**DEPARTMENT OF TRANSPORTATION****National Highway Traffic Safety Administration****49 CFR Part 572**

**Anthropomorphic Test Devices; Hybrid III 6-Year-Old Child Test Dummy**

**ACTION:** Notice of proposed rulemaking (NPRM).

**SUMMARY:** Today's NPRM proposes two changes to the agency's specifications for the Hybrid III six-year-old child dummy. In Part 1 of this NPRM, to improve the durability of the dummy's femurs, we propose changes to the design of and material used for the femur assembly. In Part 2, the drawing for the abdomen insert would be corrected so that the abdominal insert dimensions on the drawing reflect the actual part. Part 2 of this rulemaking commenced in response to a petition for rulemaking submitted by Denton ATD (Denton) and First Technology Safety Systems (FTSS). This document declines the petitioners' suggestion to investigate tolerances for vinyl and rubber components of the dummy and to specify the expected time frame each part would meet the tolerances.

Figure 1: Illustration of femur assembly

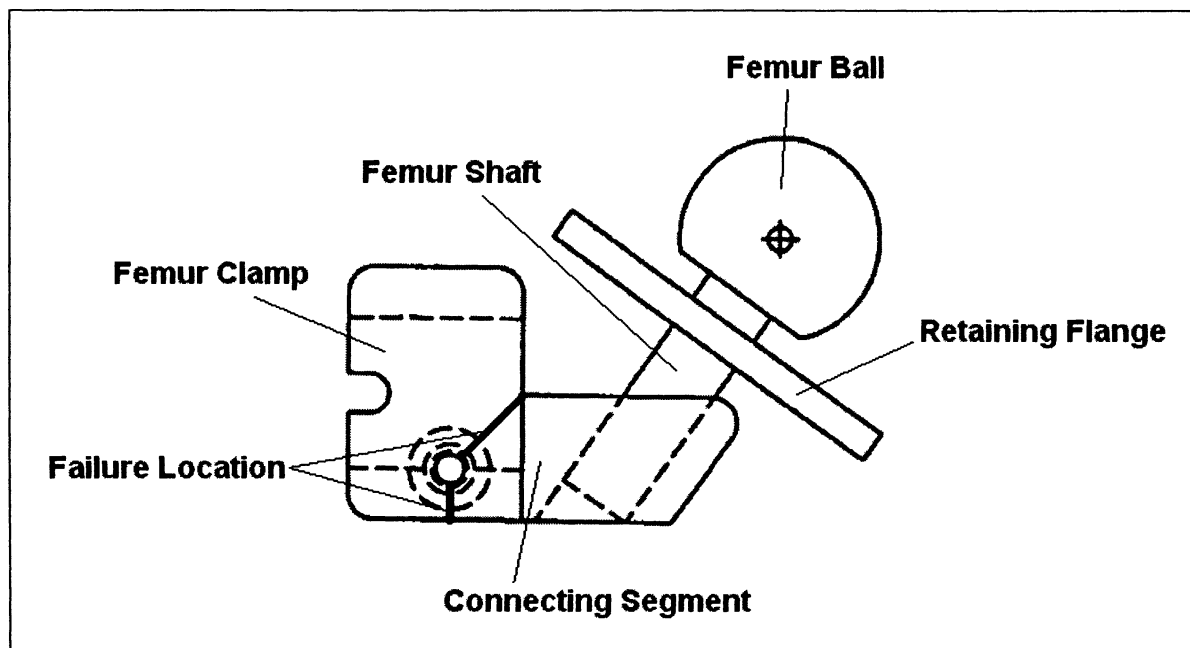
Failures of the HIII–6C femur appear to have initiated at a sharp corner between the femur clamp and connecting segment sections of the machined femur. The fracture was observed from this corner to the bolt hole within the femur clamp, at an angle of approximately 45°. The failure continued through the thin section of material directly beneath the bolt hole, causing complete separation of the machined femur. Additionally, in one failed component, small indents on the inner diameter of the retaining flange were observed, indicating potential contact between the flange and shaft. The location of the fracture is depicted in the Figure 1 illustration. Pictures of

The proposed modification to improve the femur’s durability is based on the approach developed by FTSS. The agency decided on that approach over Denton’s because the FTSS design was more straightforward and simpler than that of Denton,<sup>6</sup> and a similar design change had demonstrated improvement in the HIII–10C. Rather than re-designing, FTSS increased the strength and durability of the femur assembly by fabricating the machined femur and shaft from 4340 steel, which has a higher yield strength than the

original material, aluminum bronze C–624 AMC0–18, while keeping the ball and retaining flange as the original aluminum bronze material. A ¼-inch (6.35 mm) circular fillet was added between the femur clamp and the connecting segment to eliminate stress-risers that were present on the original femur, and a portion of the connecting segment material near the femur clamp was removed. The weight of the new FTSS femur is only 0.002 lb (0.001 kilograms (kg)) heavier than the original femur. Table 1 below compares the weights and material properties of the original femur, the FTSS-developed femur, and the Denton-developed femur.

To implement this change in femur design and material, the following changes would be made to the materials describing the HIII-6C in 49 CFR Part 572. Drawings 127-3017-1&-2, “6 YR H3—FEMUR MACHINED” would be replaced with drawings 127-3017-1S&-2S, which show the proposed machined femur.<sup>7</sup> The femur assembly drawings (127-3016-1&-2) would also be changed due to the new femur design, with new part numbers 127-3016-1S&-2S. Higher assembly drawings including 127-3000, “LOWER TORSO ASSEMBLY,” and the complete assembly drawings (127-0000) would be amended to show the proposed part. These revisions would be noted on drawing SA572-127DRL-2. The PADI would also be updated so that it shows the proposed machined femur in figures and reports the proper lower torso assembly and total weight for the dummy. Finally, the part numbers for the machined femur and the femur assembly would be changed in the Parts/Drawings list, along with the revision letters for higher assembly drawings, as appropriate. Copies of the HIII-6C drawing package, PADI, and Parts/Drawings list that include the proposed change in femur design can be obtained online at <http://www.regulations.gov>, in the same docket as this NPRM.

**Figure 7: Portions of the HIII-6C Abdomen Insert drawing**

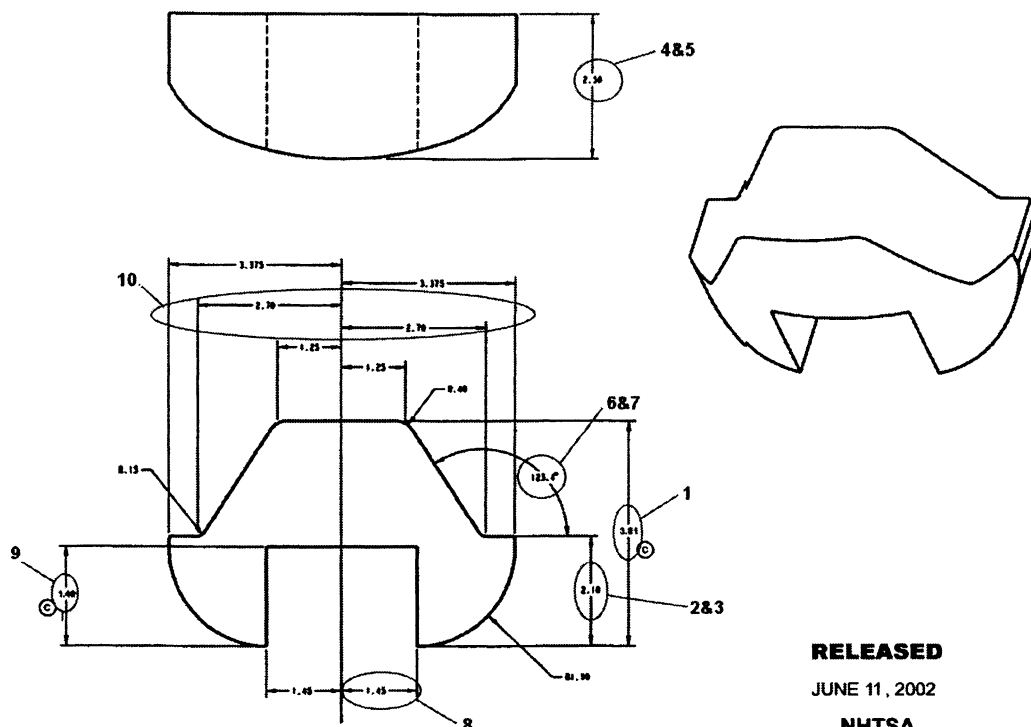
FTSS and Denton petitioned NHTSA to change Drawing No. 127–8210 of the HIII–6C drawing package, which specifies the abdominal insert for the dummy. The petitioners stated that FTSS owns the original mold for the abdominal insert that was part of the dummies used by NHTSA to develop the 49 CFR Part 572 specifications for the dummy, and that the mold is still being used to manufacture the HIII–6C dummies. The petitioners stated that they have measured the mold to compare its dimensions to those of the drawing and have “a number of discrepancies between the mold and the drawing.” The petitioners stated that Denton has also measured its abdominal insert mold, and has found it to match the FTSS mold dimensions. Both

manufacturers stated their belief that Drawing No. 127–8210 is in error because of these discrepancies, and have asked NHTSA to revise the abdomen insert drawing to match the part mold dimensions. The petitioners submitted a revised drawing as part of their petition for rulemaking which provided new dimensions for the ledge height, depth, and taper angle of cone.

We tentatively agree with the petitioners that several dimensions of the abdomen should be revised. Although the recommended dimensional changes are mostly based on agency measurements of physical parts, nearly all changes are in agreement with the petitioners' mold-based dimensions. The recommended action would incorporate the petitioner-recommended changes in dimension to the ledge height and overall depth. The taper angle of the cone dimension would also be changed to include the range of angle requested by the petitioner, but have a nominal value of  $125^\circ$  rather than  $122.4^\circ$ , and an increased tolerance of  $\pm 4^\circ$  to account for the range of angles measured in the available parts.

However, there are two small dimensional discrepancies between the part and drawing that were not addressed in the petition: The notch half width and notch depth dimensions. We are adjusting the notch half width dimension based on measurements of abdominal inserts at VRTC. The notch half width measurements were all larger than the specified nominal dimension of 1.45 inches, and one measurement fell outside the allowed tolerance. Therefore, a slight increase in this dimension to 1.50 inches is proposed. The suggested changes to the abdominal insert drawing are reflected in Table 4

under “Proposed Spec.” We have decided not to adjust the notch depth dimension based on part measurements, because only one out of five measurements did not meet the specification, and the age of this part may have affected this dimension. This decision is discussed more fully in the technical report.
